In the Office Action dated February 13, 2002, all of the claims (1 - 31) were rejected under 35 U.S.C. § 103. By this amendment, Applicants have amended the drawings and the specification to correct several typographical errors.

Amendments to the Drawings

Application No. 09/691,632

FIG. 1

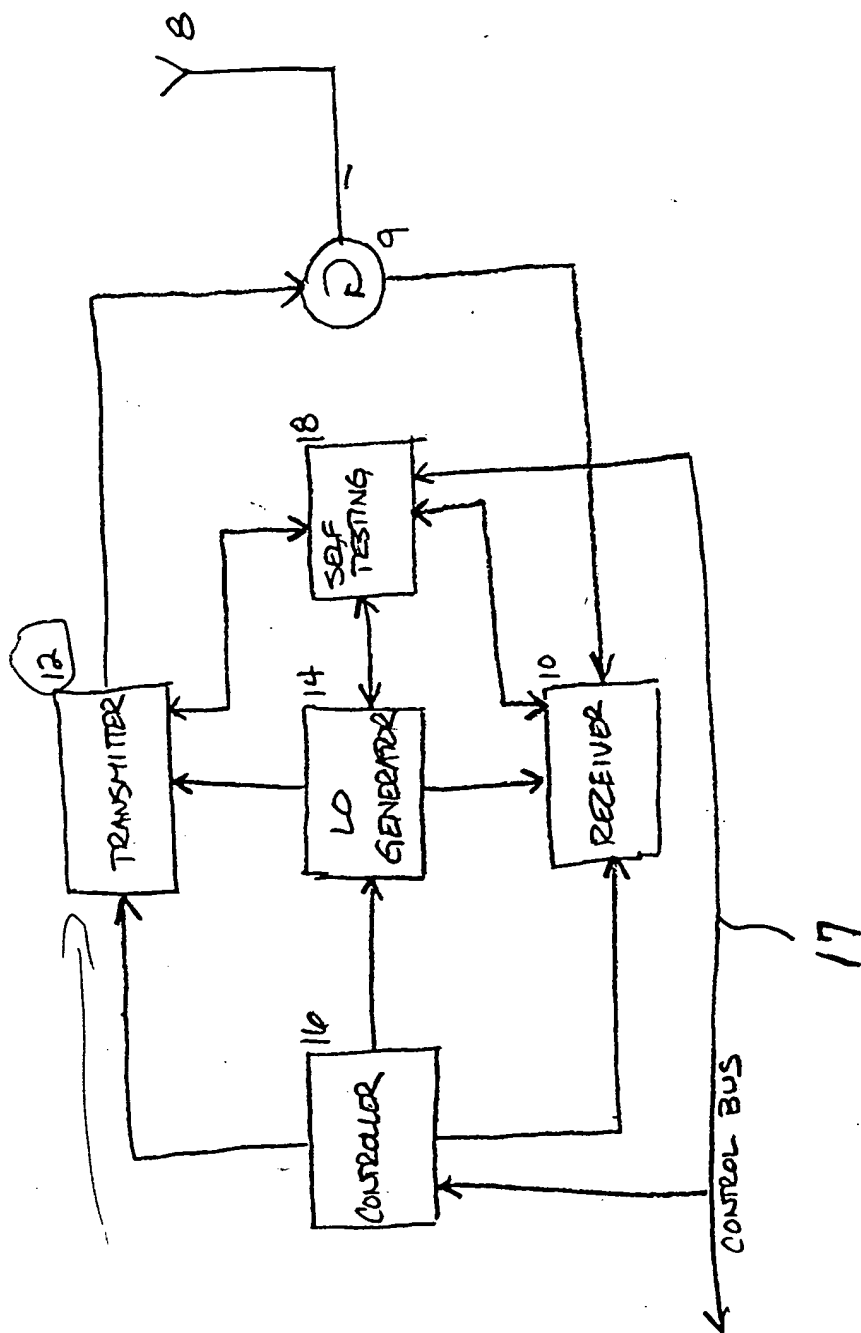
Figure 1 has been amended to add reference designation 17 to the control bus. This is supported in the specification, for example, at page 11, line 14: "control bus 17."

Fig. 2

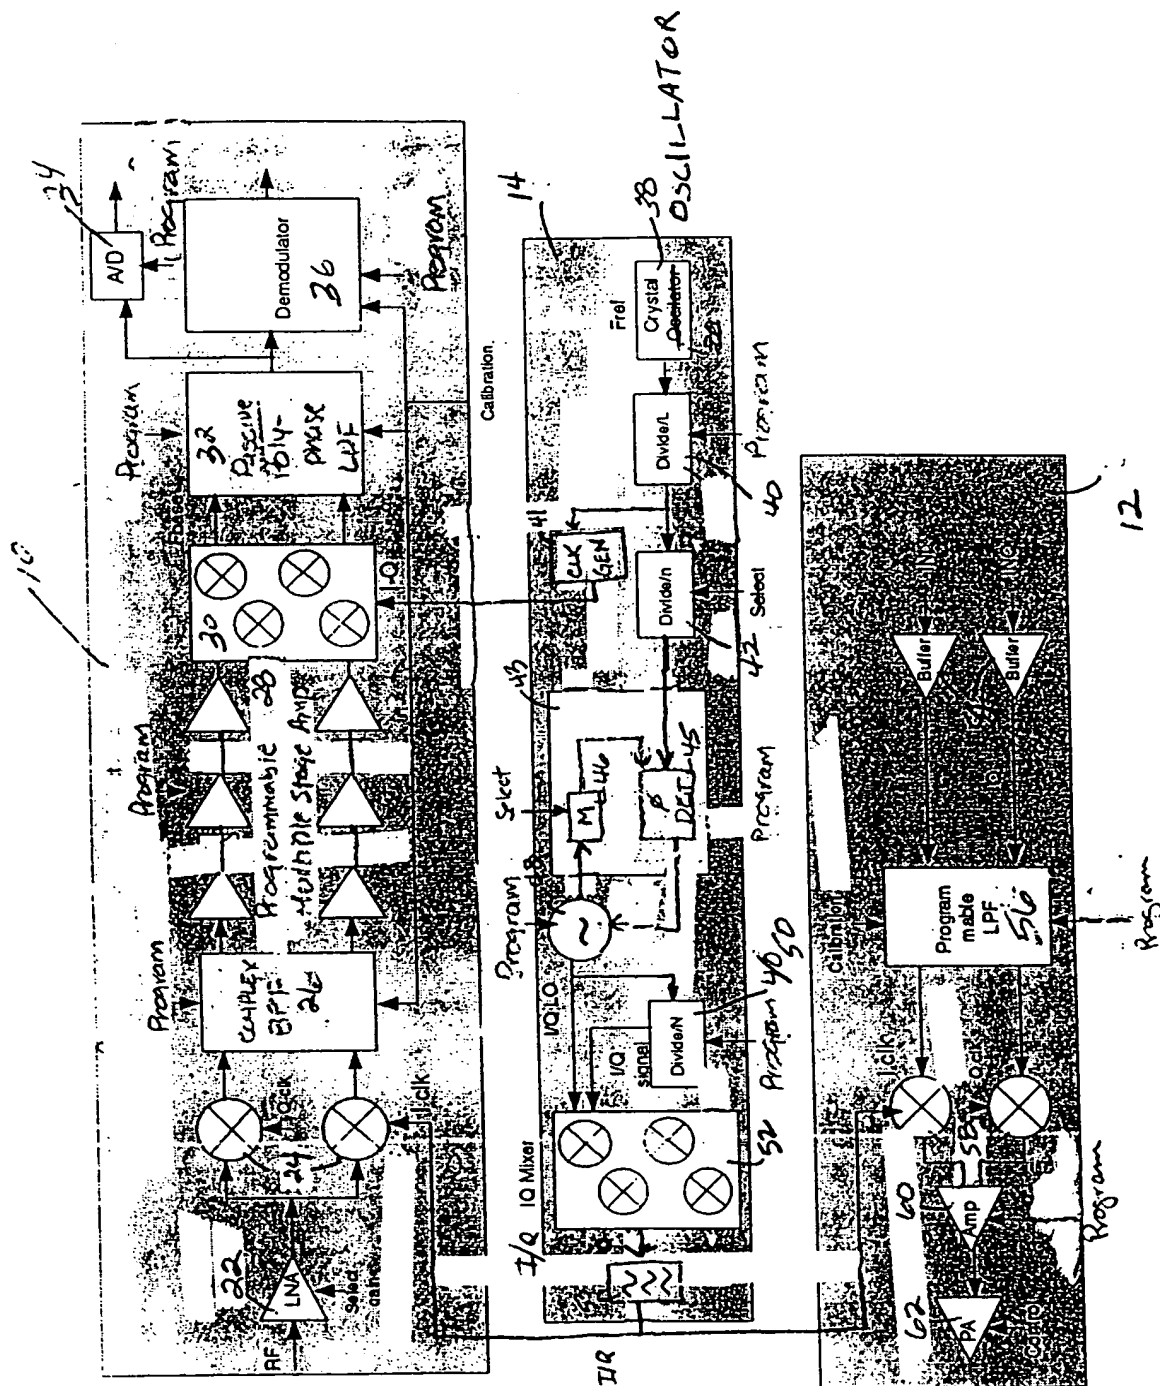
Figure 2 has been amended as follows:

A line has been added between components 52 and 53. This is supported in the specification, for example, at page 14, lines 29 - 30 where is explained that the output of the mixer 52 goes to the filter 53: "A filter 53 can be positioned at the output of the complex mixer."

The line added between components 52 and 53 is labeled "I/Q." This is supported in the specification, for example, at page 15, lines 19 - 22, where it is explained that the output of the mixer 52 may be an I/Q signal: "... the mixer 52 can be configured as a double quadrature mixer ... to generate the Q-clock and ... the I-clock."

A spelling error has been corrected in the label for the crystal oscillator 38.

The reference numeral 40 for the "DIVIDE / N" component has been corrected to designate reference numeral 50. This is supported in the specification, for example, at page 14, line 27: "divide by N circuit 50."

FIG. 4

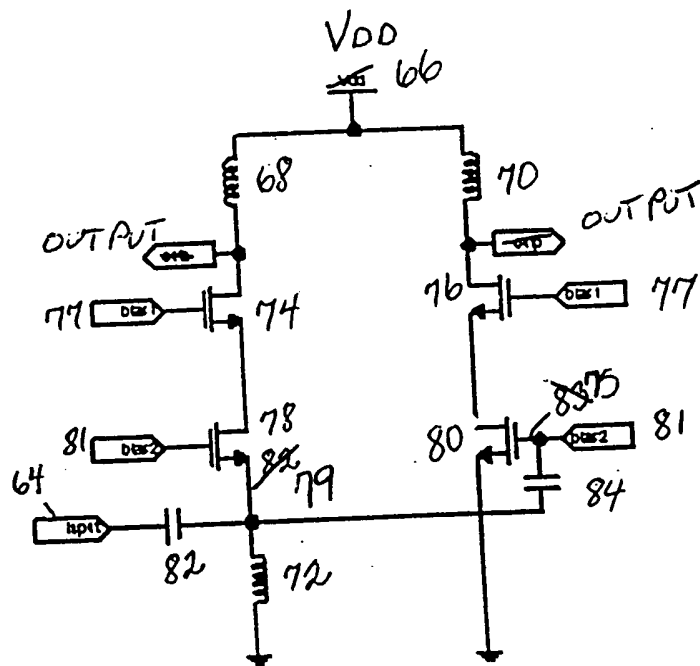
Figure 4 has been amended as follows:

Reference numeral 82 has been changed to 79.

Reference numeral 83 has been changed to 75.

These reference numerals have also been changed in the specification at page 18, lines 12 and 15 as set forth in the "Version with markings to show changes made.". These changes were made to correct duplicate use of the reference numerals 82 and 83.

The abbreviation "OUTP" has been changed to the complete word "OUTPUT."

FIG. 4(a)

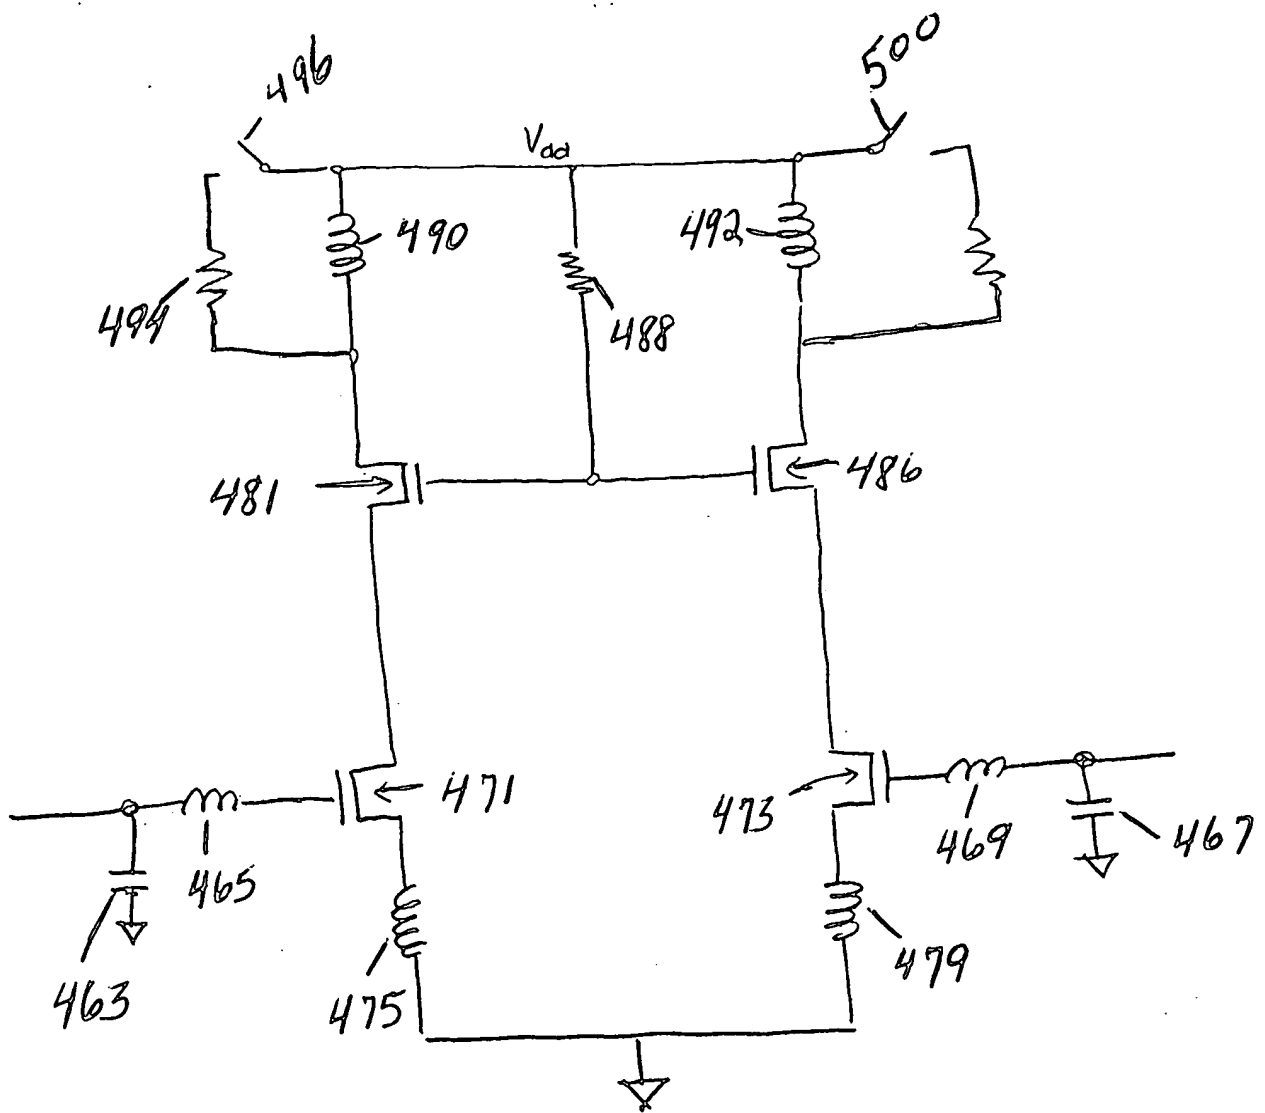
Figure 4(a) has been amended to add all of the reference numerals and to add four components.

The following reference numerals have been added: 463, 465, 467, 469, 471, 473, 475, 479, 481, 486, 488, 490 and 492.

The following components have been added: 494, 496, 498 and 500.

These reference numerals and components were inadvertently omitted from the drawing for Figure 4(a), however, these numerals and components are clearly described in the specification as being in Figure 4(a).

FIG. 7

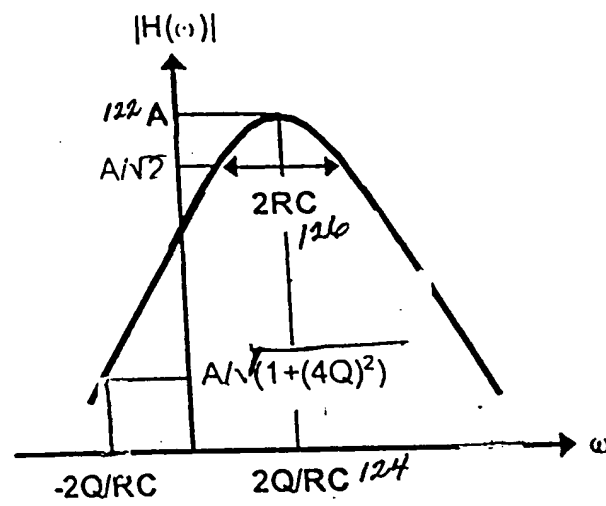
Figure 7 has been amended to complete the “square root” symbol. This is supported, for example, by the discussion at page 24, line 7 of the amplitude of the image being rejected by the square root of $1 + (4Q)^2$.

FIG. 14

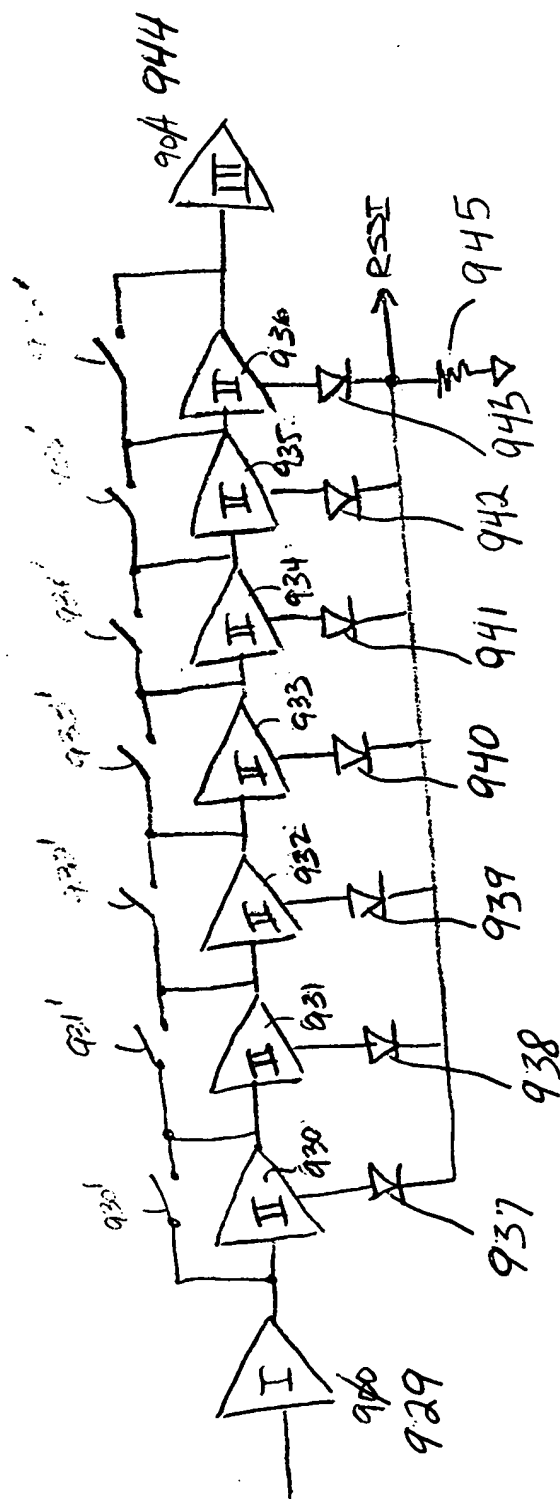
Figure 14 has been amended as follows:

Reference numeral 900 has been changed to 929. Reference numeral 904 has been changed to 944. These reference numerals have also been changed in the specification at page 32, line 8. These changes were made to correct duplicate use of the reference numerals 900 and 904.

The following reference numerals have been added: 937, 938, 939, 940, 941, 942, 943 and 945. These reference numerals were inadvertently omitted from the drawing for Figure 14, however, these numerals are clearly described in the specification as being in Figure 14. See, for example, page 33, lines 4 - 7: “The voltage at the output of each differential amplifier 930, 931, 932, 933, 934, 935, 936 is coupled to a rectifier 937, 938, 939, 940, 941, 942, 943, 944, respectively. The outputs of the rectifiers are connected to ground through a common resistor 945.”

FIG. 17(a)

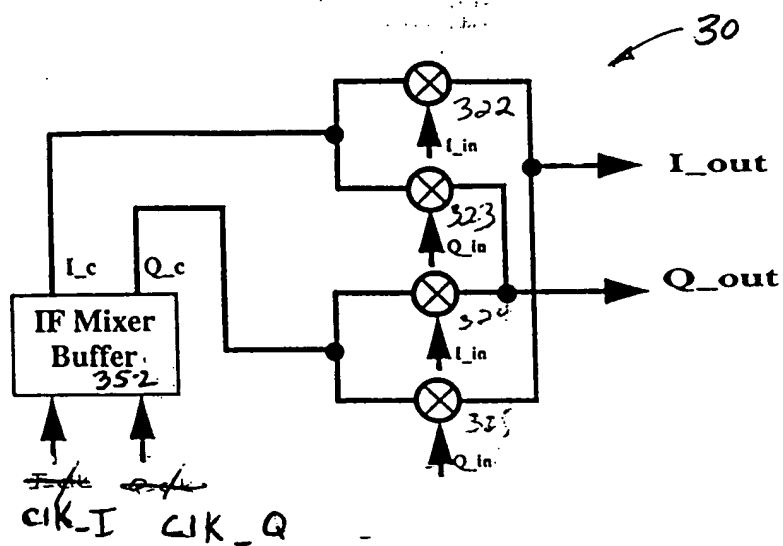
Figure 17(a) has been amended to change the labels I_clk and Q_clk to clk_I and clk_Q, respectively. This is supported in the specification, for example, at page 43, lines 31 - 32 where it is explained that the names of the input signals for the IF MIXER BUFFER 352 are clk_I and clk_Q: “The clock generator outputs clk_I and clk_Q for the IF mixer buffer (see figure 17).”

FIG. 23

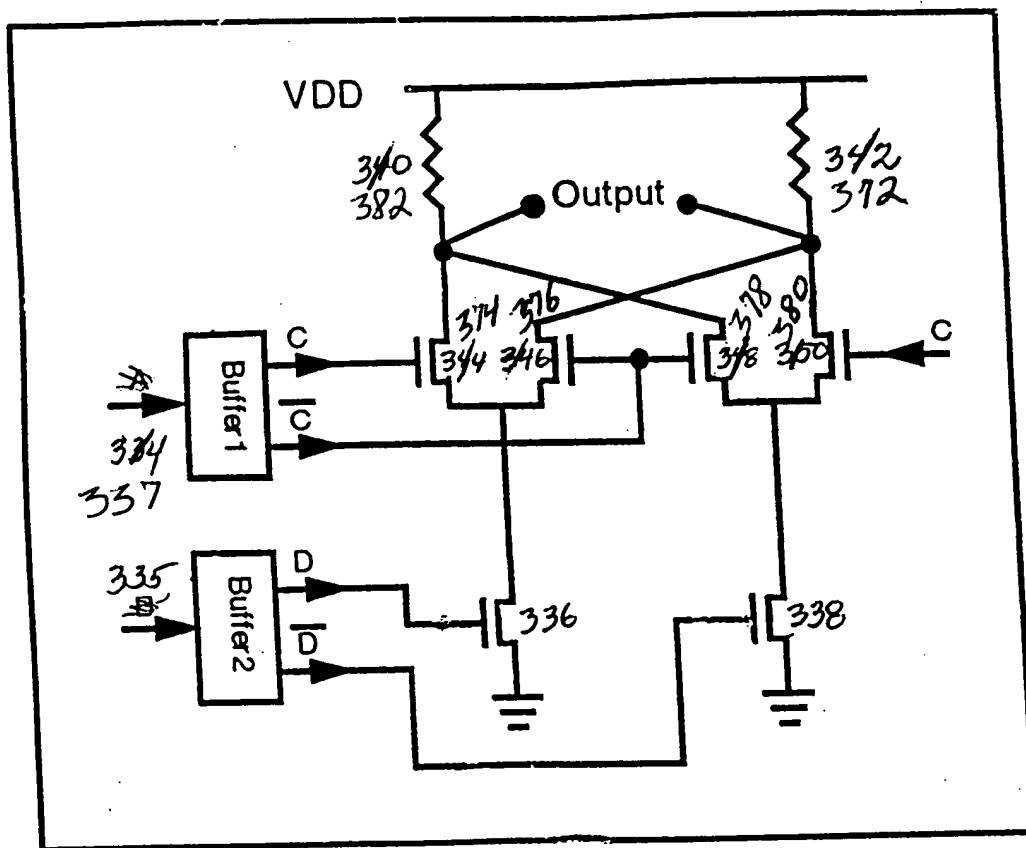
Figure 23 has been amended to correct duplicate use of the reference numerals 334, 340, 342, 344, 346, 348 and 350.

Reference numeral 334 has been changed to 337.

Reference numeral 340 has been changed to 382.

Reference numeral 342 has been changed to 372.

Reference numeral 344 has been changed to 374.

Reference numeral 346 has been changed to 376.

Reference numeral 348 has been changed to 378.

Reference numeral 350 has been changed to 380.

FIG. 32

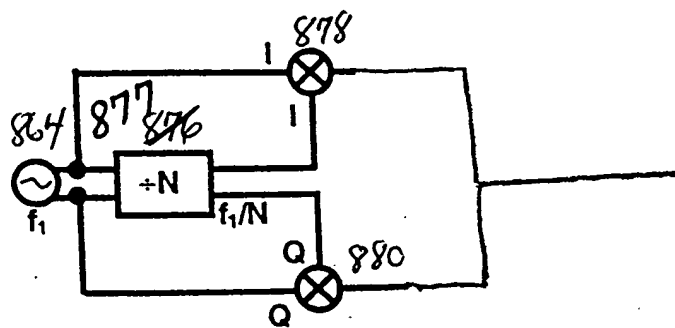
Figure 32 has been amended to correct duplicate use of the reference numeral 876. Reference numeral 876 has been changed to 877. This reference numeral has also been changed in the specification at the paragraph beginning at page 55, line 5 as set forth in the **"Version with markings to show changes made."**

FIG. 33

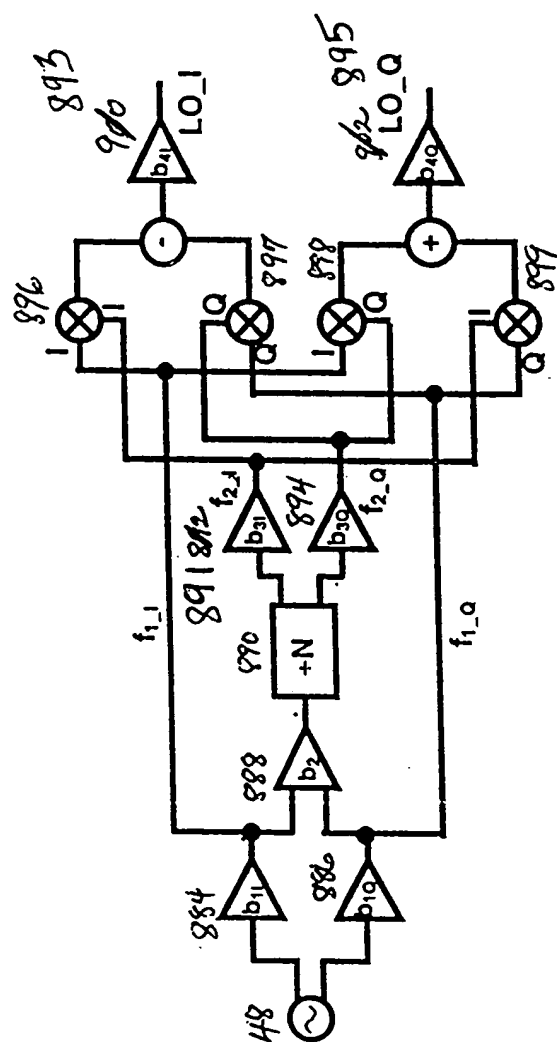
Figure 33 has been amended to correct duplicate use of the reference numerals 892, 900 and 902.

Reference numeral 892 has been changed to 891.

Reference numeral 900 has been changed to 893.

Reference numeral 902 has been changed to 895.

FIG. 33(a)

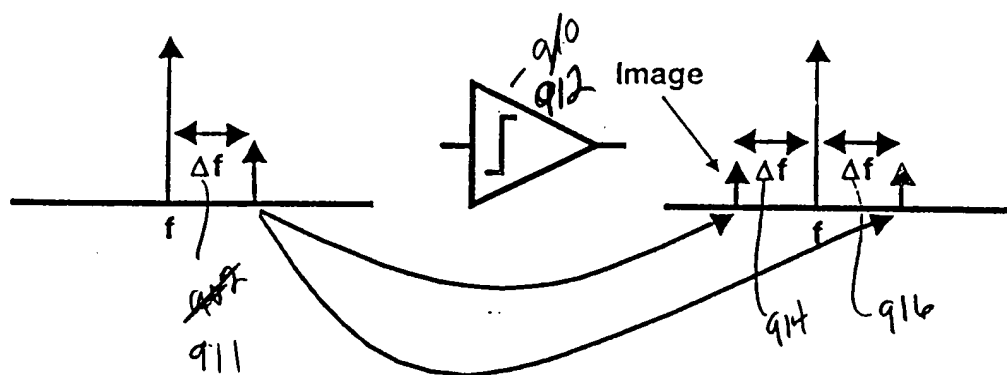
Figure 33a has been amended to correct duplicate use of the reference numerals 902 and 910.

Reference numeral 902 has been changed to 911.

Reference numeral 910 has been changed to 912.

FIG. 40

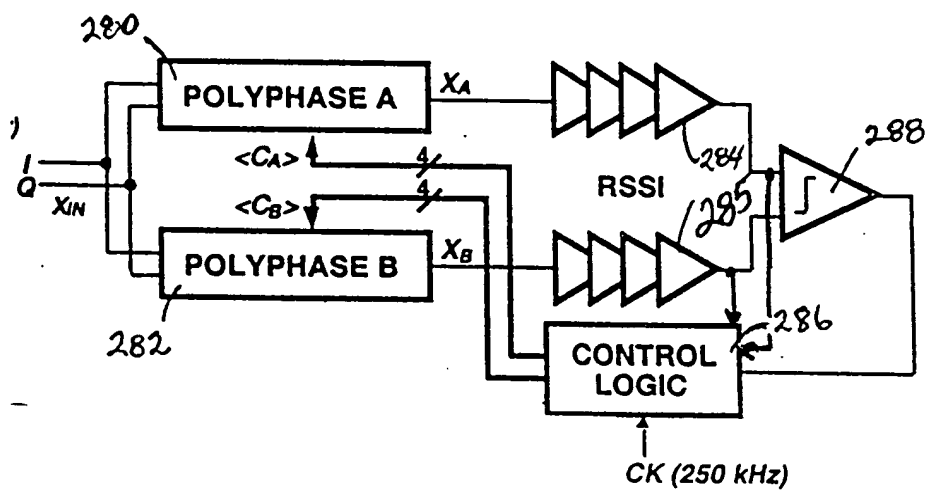
Figure 40 has been amended to add reference numeral 285 that was inadvertently omitted from the drawing for Figure 40. As described, for example, at page 72, lines 25 - 26, reference numeral 285 is clearly described in the specification as being in Figure 40: "The signals at the outputs of the polyphase filters are detected with a received-signal-strength-indicator (RSSI) block 284, 285 in each path."

FIG. 45

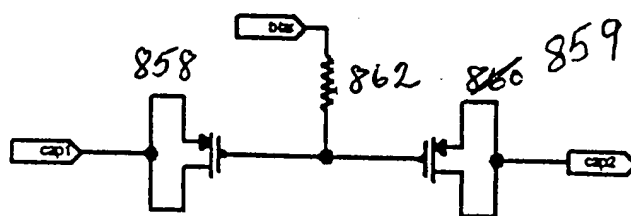
Figure 45 has been amended to correct duplicate use of the reference numeral 860. Reference numeral 860 has been changed to 859. This reference numeral has also been changed in the specification at the paragraph beginning at page 78, line 15 as set forth in the **"Version with markings to show changes made."**
